ACCESSION NBR: 8309260140 DOC. DATE: 83/09/09 NOTARIZED: NO DOCKET #
 FACIL: 50-275 Diablo Canyon Nuclear Power Plant, Unit 1, Pacific Ga 05000275
 AUTH. NAME AUTHOR AFFILIATION
 SCHUYLER, J.O. Pacific Gas & Electric Co.
 RECIP. NAME RECIPIENT AFFILIATION
 EISENHUT, D.G. Division of Licensing

SUBJECT: Forwards list of unresolved items & response to remaining items of Suppl 18 to SER, per request at 830901 meeting. Items include final verification & completion &/or documentation of some mods.

Re: Docket No. 50-275, OL-DPR-76
Diablo Canyon Unit 1
Safety Evaluation Report, Supplement No. 18

ENCLOSURE 1
SAFETY EVALUATION REPORT
SUPPLEMENT NO. 18
STATUS OF UNRESOLVED ITEMS

Figure V-34. Typical Blowdown and Sample System Design

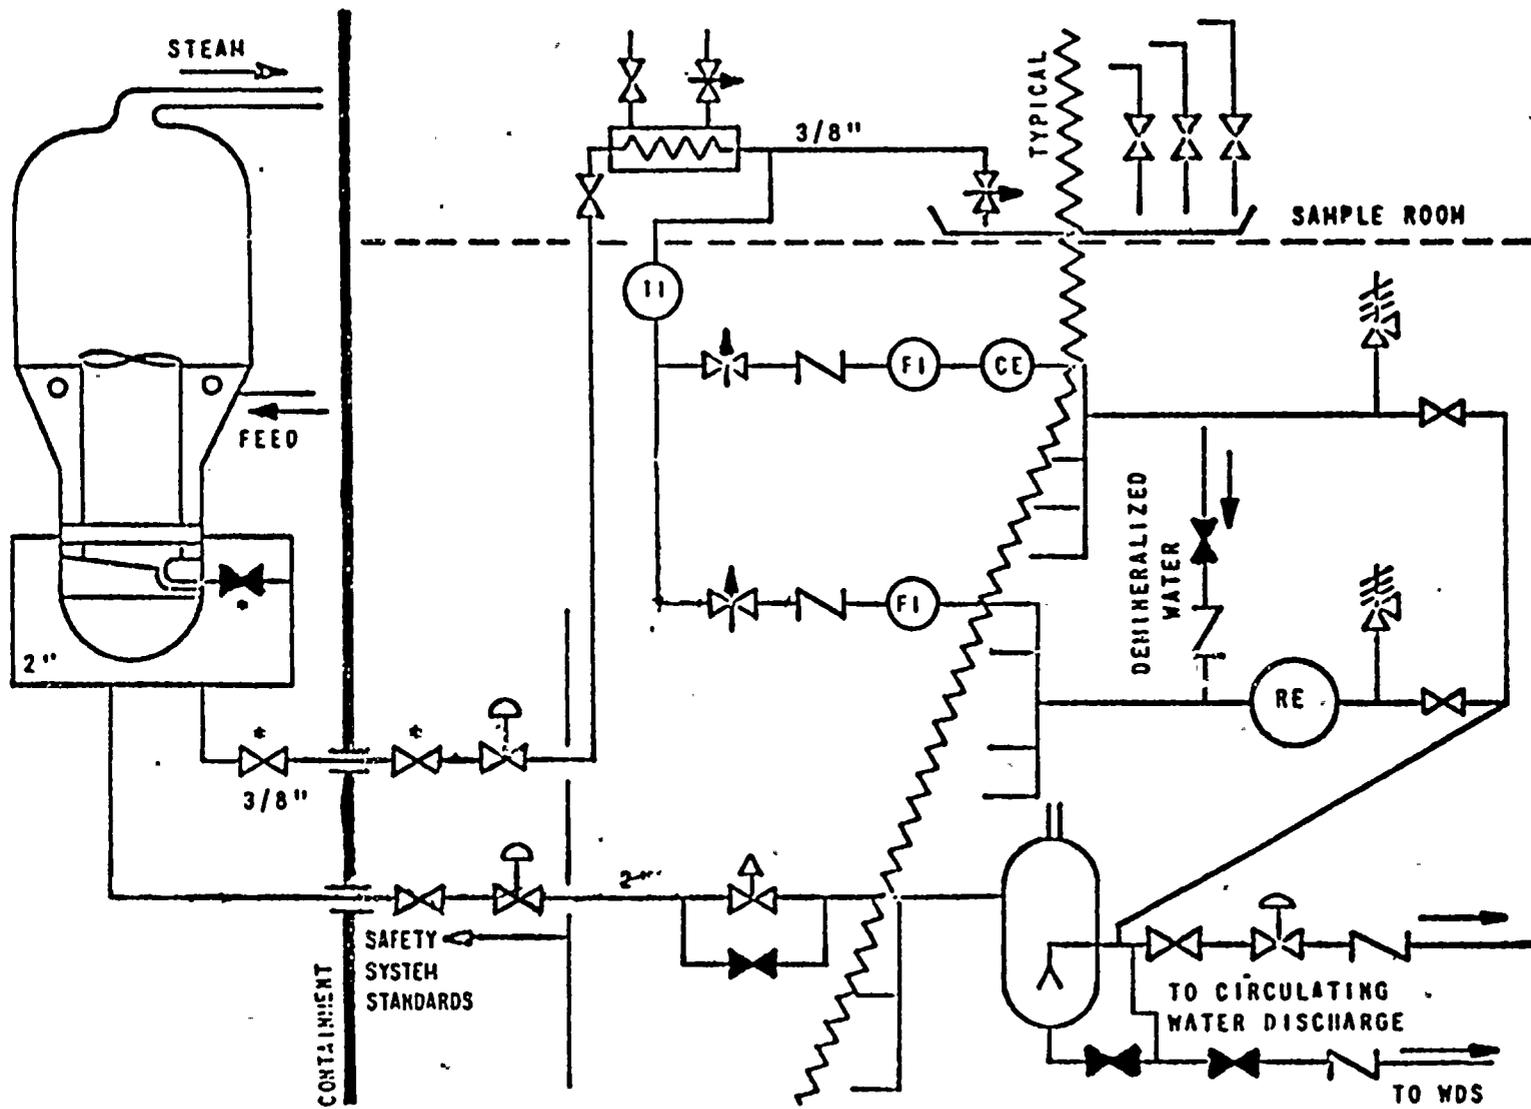
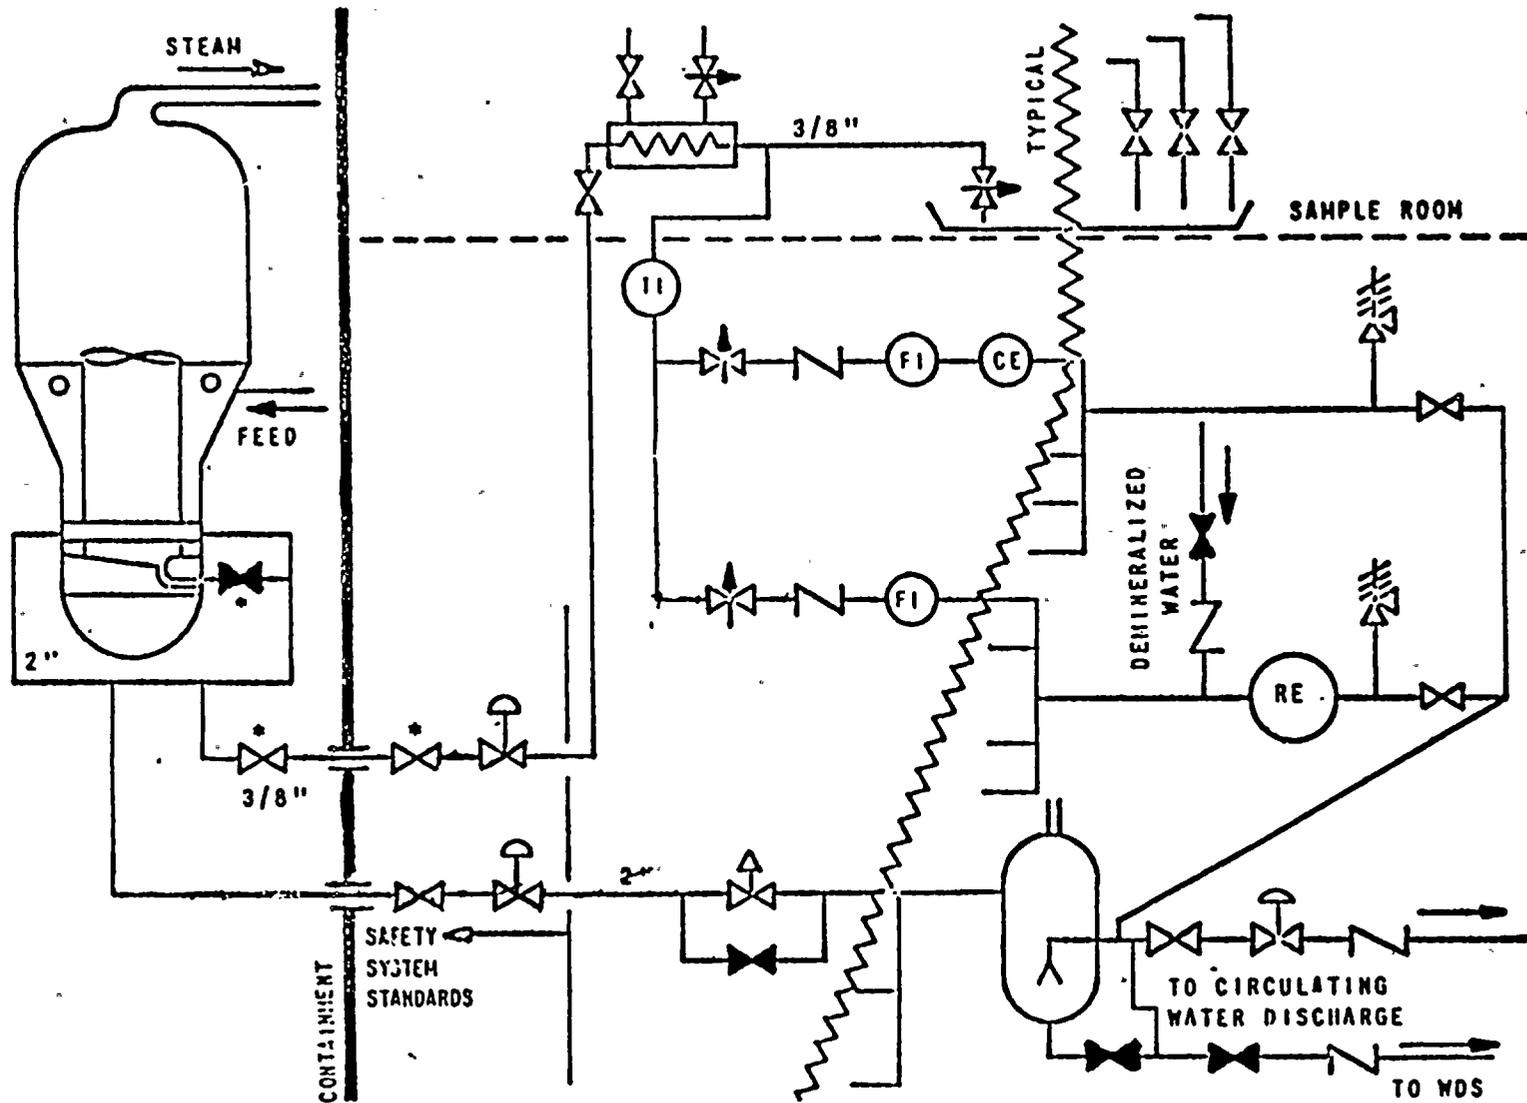
"The staff...finds that the use of a single relay to isolate steam generator blowdown on automatic initiation of the AFWS is in conflict with the design shown in FSAR Figure 7.2-1, Sheet 15. Further, the redundancy, as shown by this figure, typical for all Westinghouse plants, is consistent with the Westinghouse analysis noted above which assumes that steam generator blowdown is terminated for those events not associated with safety injection. The staff concludes that the concern identified does represent a deviation from the Westinghouse interface requirements to be implemented by the balance-of-plant design."

It should be noted that there are four valves per steam generator, two within the containment and the two immediately outside. If the latter require repair because of leaks, a plant cooldown and draining of the steam generator is required. We recommend that high quality seal welded bonnet valves be specified for these locations, rather than routine field-procured valves, in order to minimize the possibility of this occurrence. These valves are marked with an asterisk in Figure V-34.

However, to close this issue in a timely manner, PGandE will install a redundant relay for steam generator blowdown isolation on auxiliary feedwater pump start as shown in PSAR Figure 7.2-1. PSAR Figure 7.3-47 will be updated to reflect the redundant relay.

FIGURE 7.2-1
INSTRUMENTATION AND CONTROL
SYSTEM LOGIC DIAGRAM
(SHEET 15 OF 16)

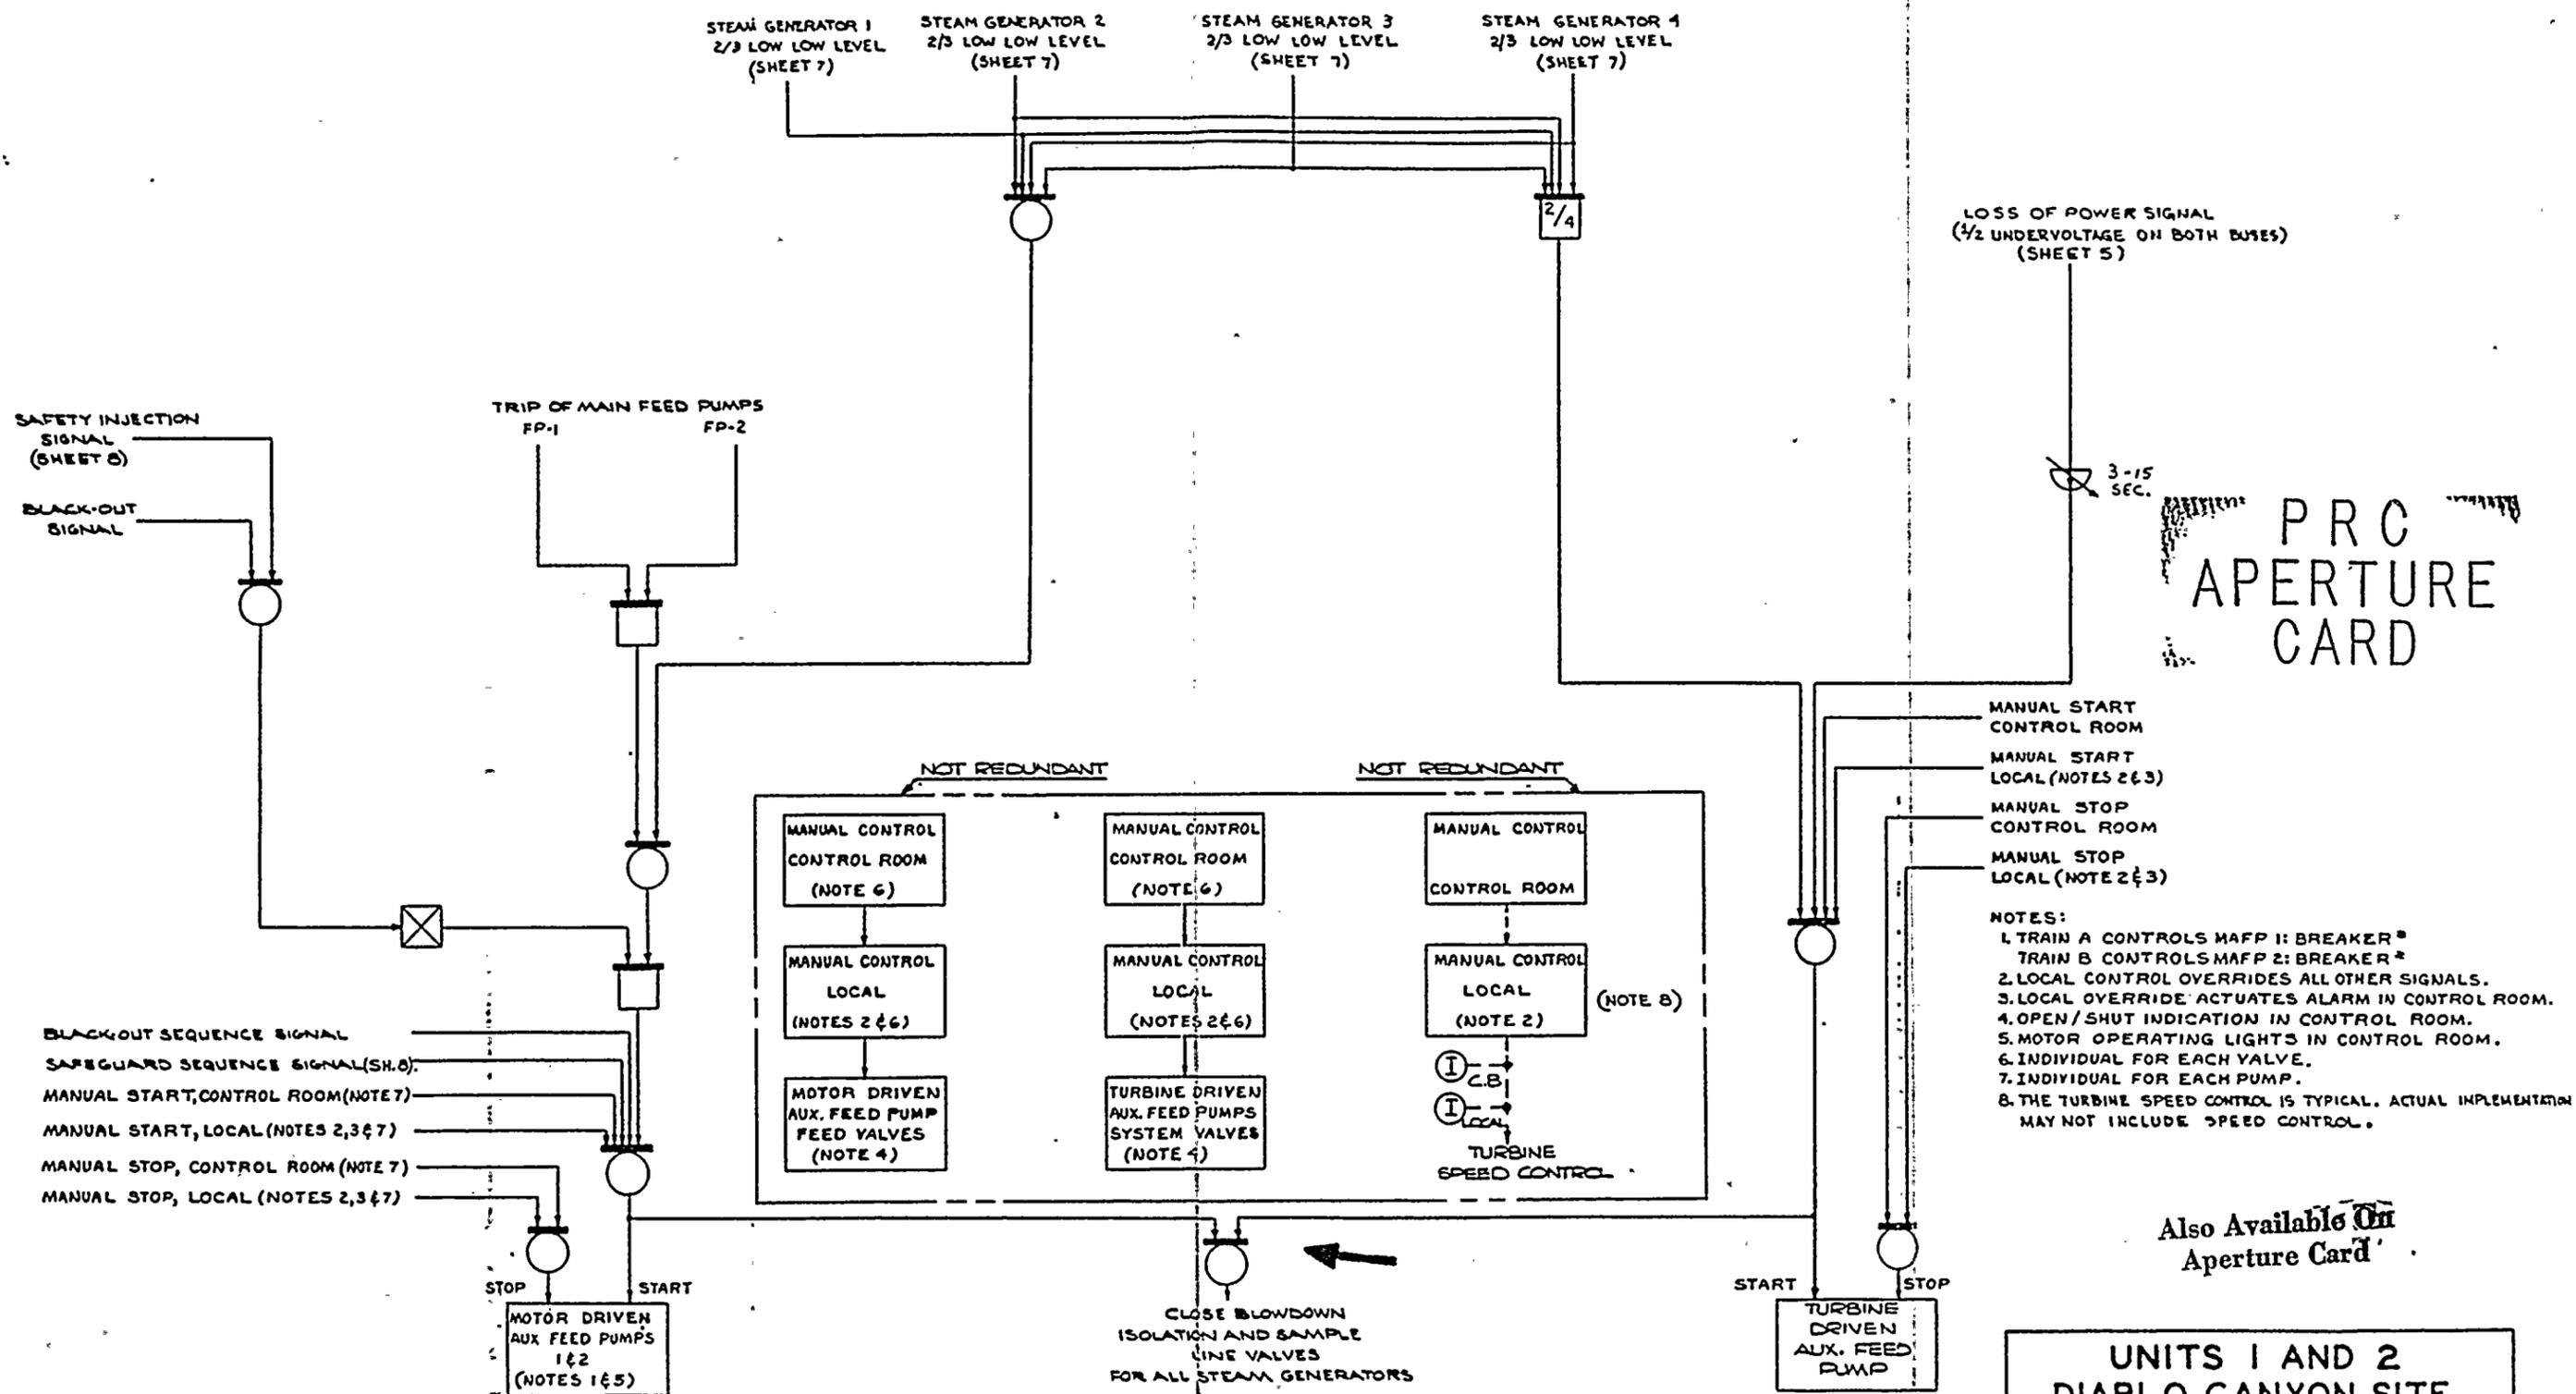
"The staff...finds that the use of a single relay to isolate steam generator blowdown on automatic initiation of the AFWS is in conflict with the design shown in FSAR Figure 7.2-1, Sheet 15. Further, the redundancy, as shown by this figure, typical for all Westinghouse plants, is consistent with the Westinghouse analysis noted above which assumes that steam generator blowdown is terminated for those events not associated with safety injection. The staff concludes that the concern identified does represent a deviation from the Westinghouse interface requirements to be implemented by the balance-of-plant design."

However, to close this issue in a timely manner, PGandE will install a redundant relay for steam generator blowdown isolation on auxiliary feedwater pump start as shown in FSAR Figure 7.2-1. FSAR Figure 7.3-47 will be updated to reflect the redundant relay.
